RE: **Lot 3 Block 10 Unit 22, S.A.D. 228**
Volcano Cliffs Subdivision
6424 Petirrojo Rd. NW
Grading and Drainage Plan
Engineers Stamp Date 5/17/18 (D10D003F3)

Based upon the information provided in your submittal received 5/18/18, this plan is approved for Grading Permit.

DRAINAGE AND TRANSPORTATION INFORMATION SHEET

DRAINAGE PLAN

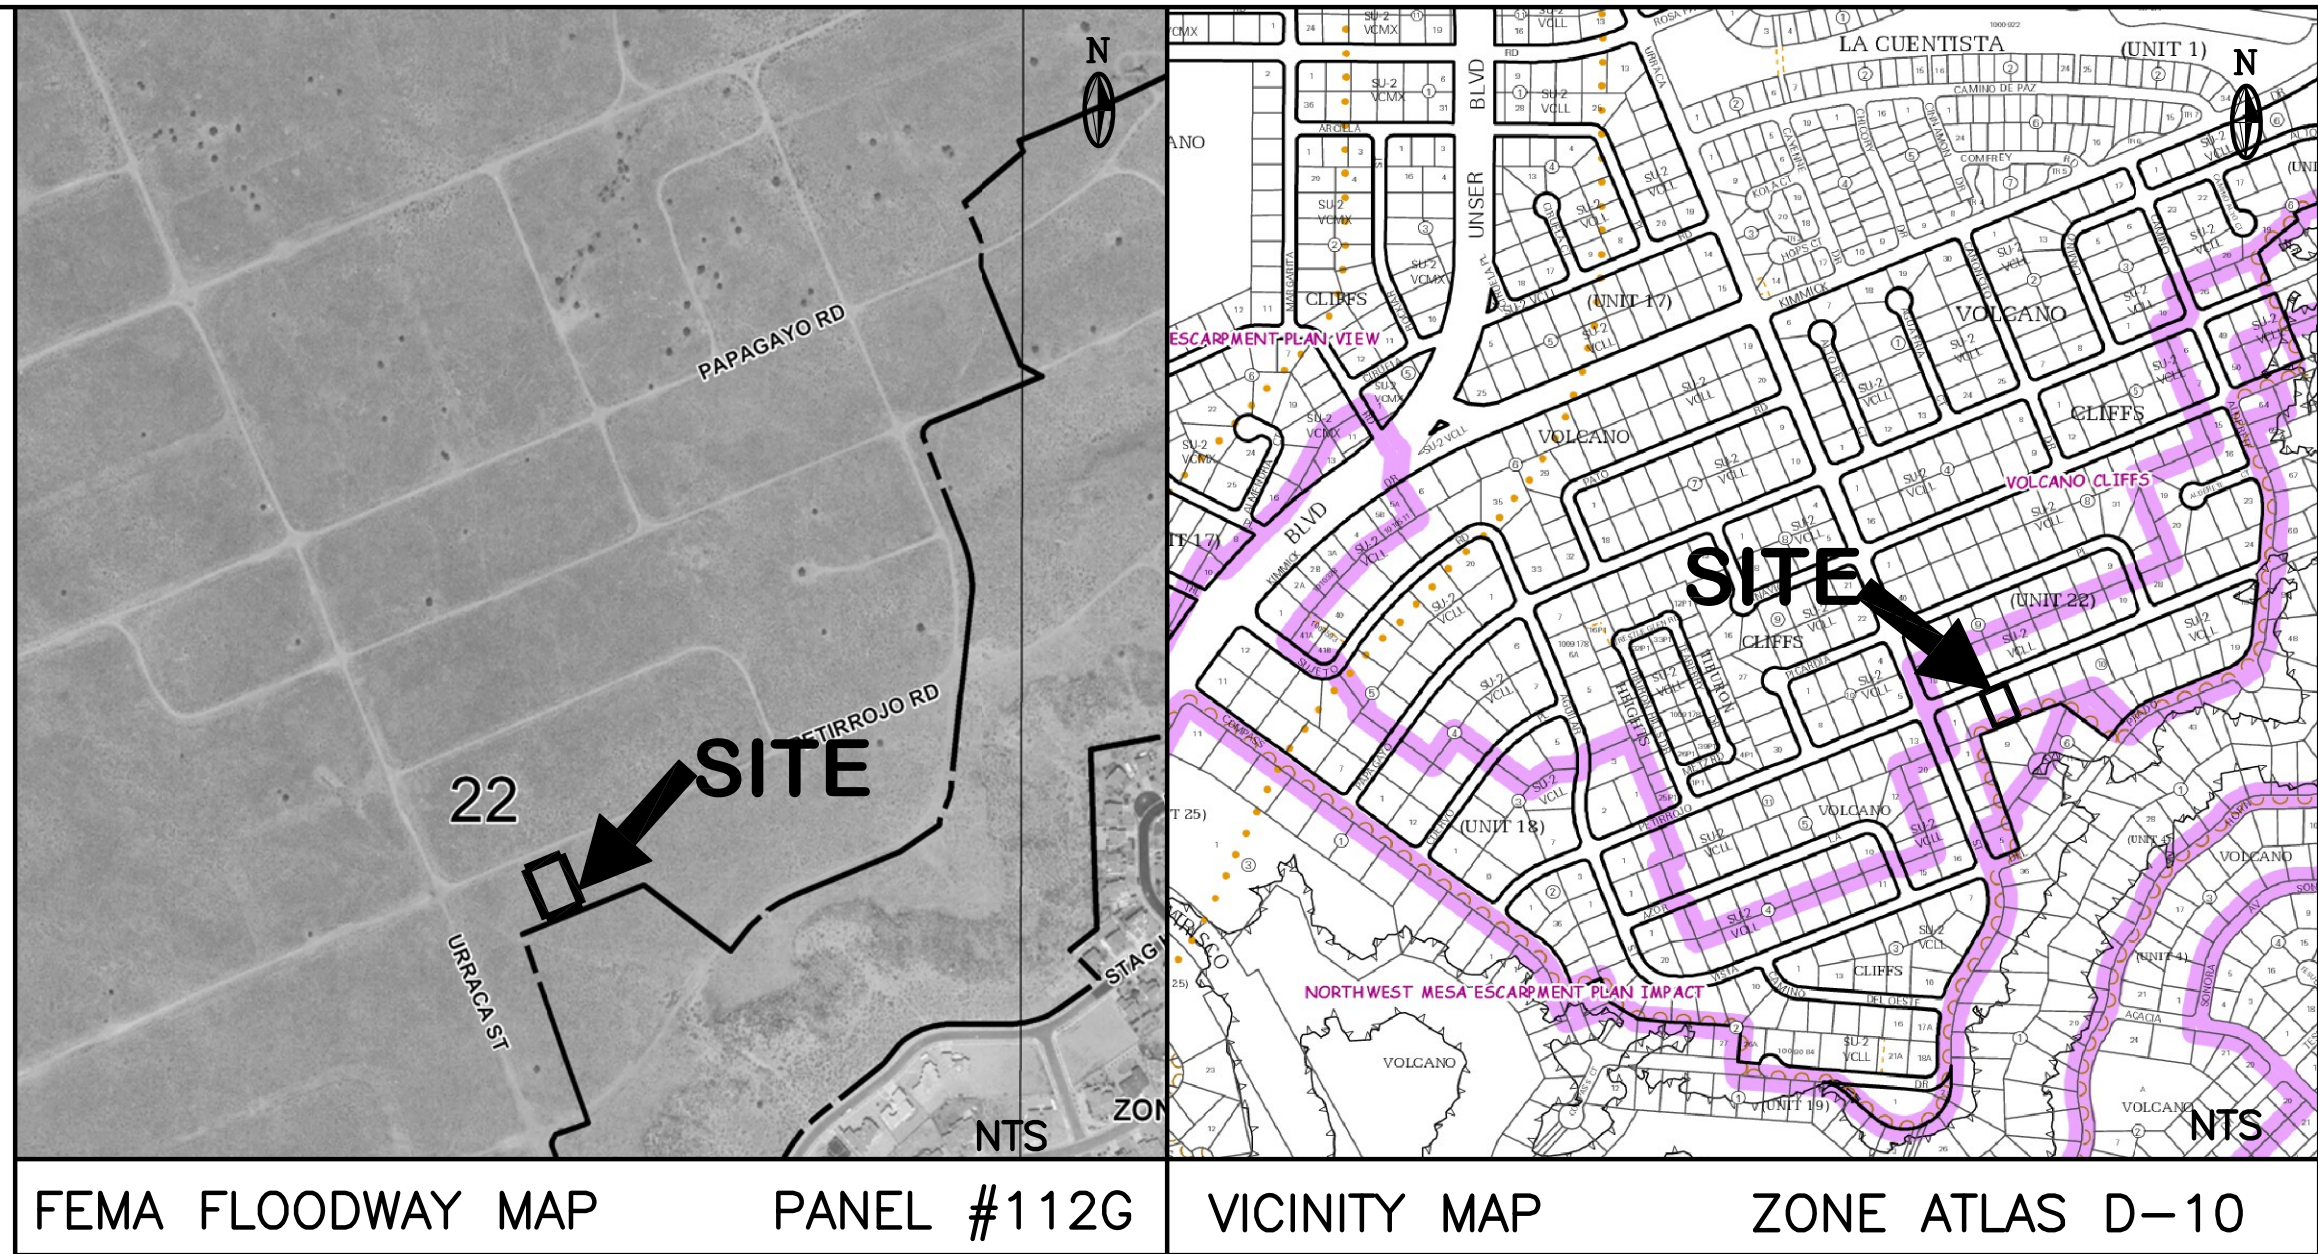
Prior to Building permit approval a Pad Certification will be required, provided by the Engineer or a registered Land Surveyor.

Reiterate to the Owner/Contractor that a separate permit for a garden/retaining wall must be obtained, with the approved G&D plan dated 5/17/18.

Prior to Certificate of Occupancy release, Engineer Certification per the DPM checklist of this plan will be required.
